Response to RC3 on Data-driven farm-wide fatigue estimation on jacket foundation OWTs for multiple SHM setups

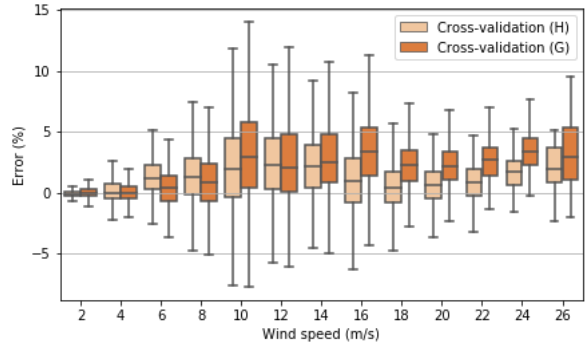
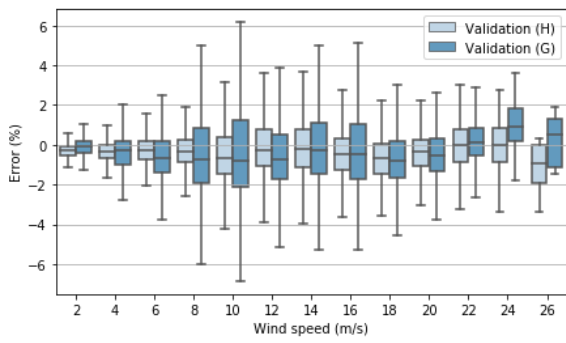
Line 451: The use of the word 'clearly' seems to contradict the initial understanding of Figure 10. This is evidenced by the need of the author to explain the lack of generalization in Line 452. If one were to choose a case that is generally 'best' based on Figure 10, it seems that scenario G performs better. Please explain how these results are used to determine the superiority of scenario H.

The use of the word 'clearly' is indeed abusive and contradicts the spirit of the text. The issue with Figure 10, and scenarios G and H, is that, albeit G presents a slightly better MAE cross-validation value, H has a better result for the validation turbine. Additionally, we can observe that the spread for both the box and whiskers of H is lower than G. If we compare the error (%) values for models H and G, we can see that for both cases the boxplots for model H have a lower spread for most wind speeds (including for cross-validation). The MAE might be marginally lower for G because it's general offset might be lower than for H. In sum, MAE is a valuable metric, but, as a single value, it can't show the entire picture. Altered sentence to: “Finally, the results for the model based on the RFE DTC selected features are the best for the turbine (H), as it presents the lower spread in its boxplots.”
